ADDENDUM 3

SUBJECT: Bulverde Rd (Green Spring Dr – Redland Rd) Street Reconstruction (2022 Bond), (ID # 23-03867), Scheduled to Close: July 21, 2026; Date of Issue: June 10, 2026

THIS NOTICE SHALL SERVE AS ADDENDUM NO. 3 – TO THE ABOVE REFERENCED INVITATION FOR BIDS

BULVERDE ROAD
(GREEN SPRING TO REDLAND ROAD)
BULVERDE RD
ADD ALT #2 PLAN AND PROFILE
STA 102+00 TO STA 106+00
SHEET 2 OF 3

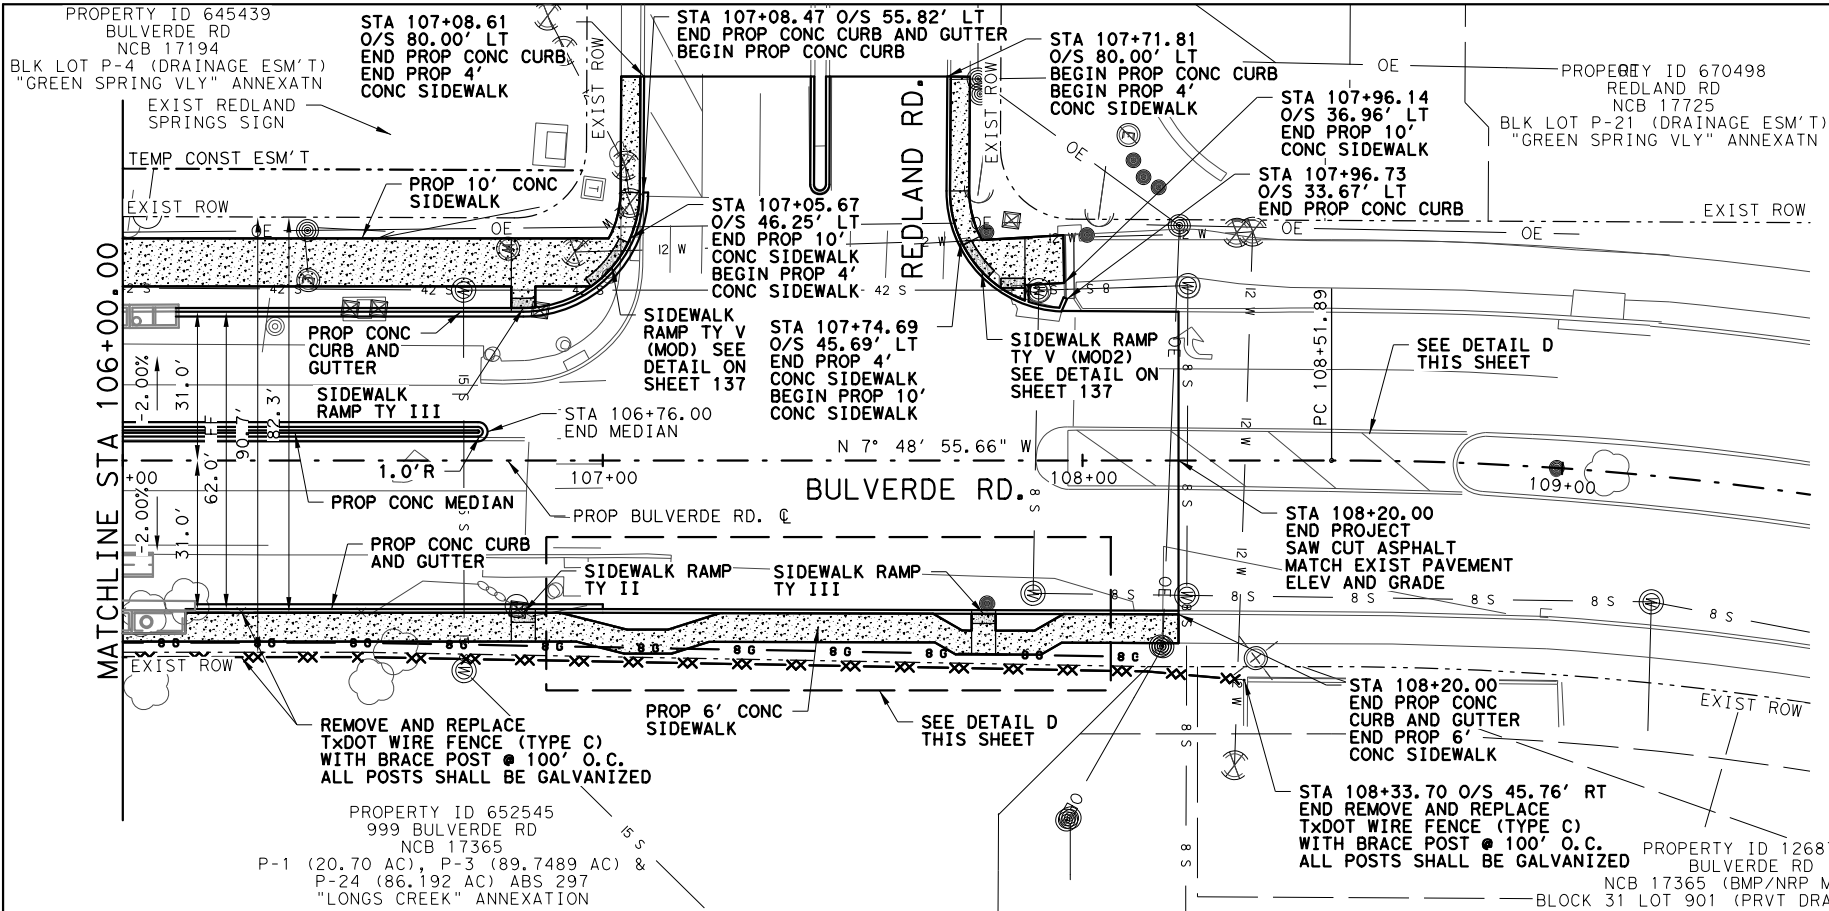
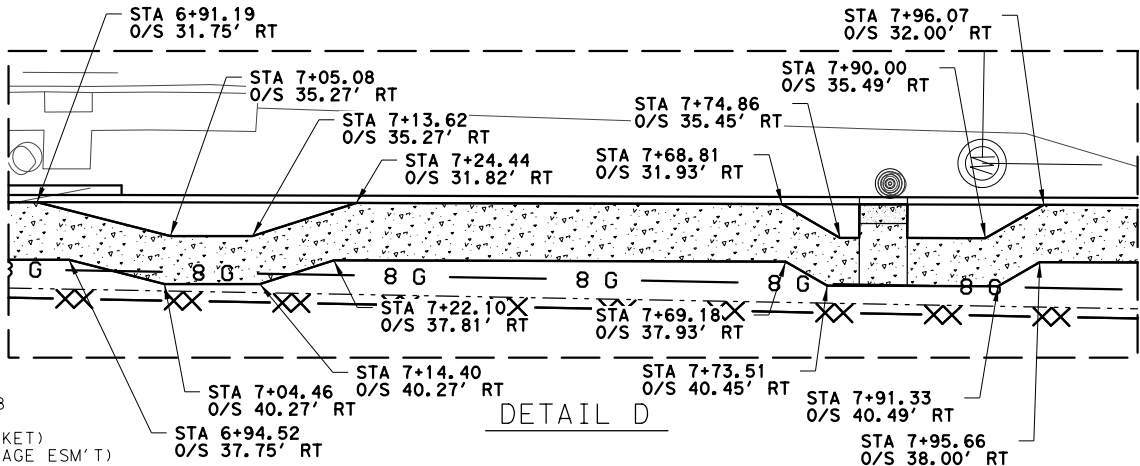
- g. REMOVE Sheet 130 and REPLACE with attached Sheet 130 to update the quantity for Item 500.4 in the quantity box on the sheet.
- h. REMOVE Sheet 131 and REPLACE with attached Sheet 131 to update the quantity for Item 500.4 in the quantity box on the sheet.

BULVERDE ROAD
(GREEN SPRING TO REDLAND ROAD)
BULVERDE RD
ADD ALT #2 PLAN AND PROFILE
STA 106+00 TO END
SHEET 3 OF 3

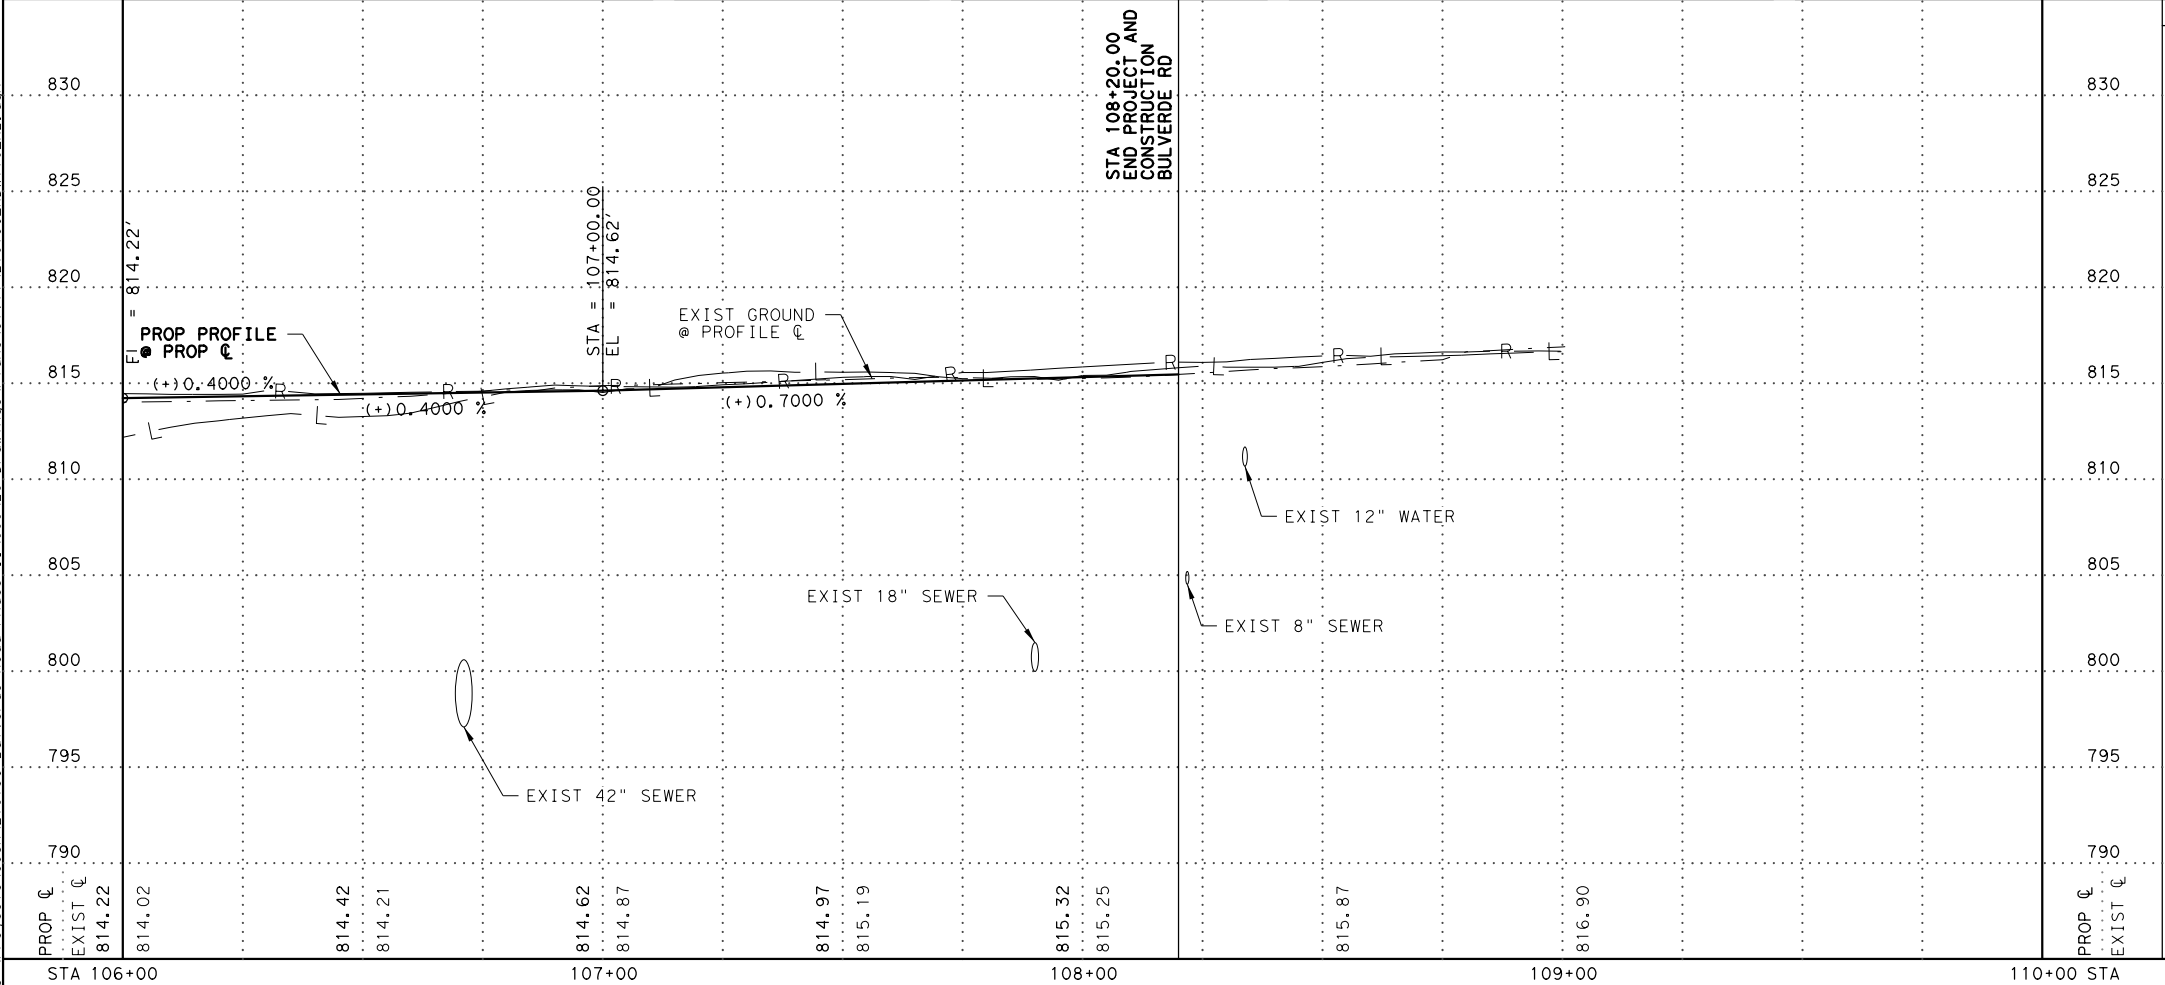
- i. REMOVE Sheet 132 and REPLACE with attached Sheet 132 to update the quantity for Item 500.4 in the quantity box on the sheet.
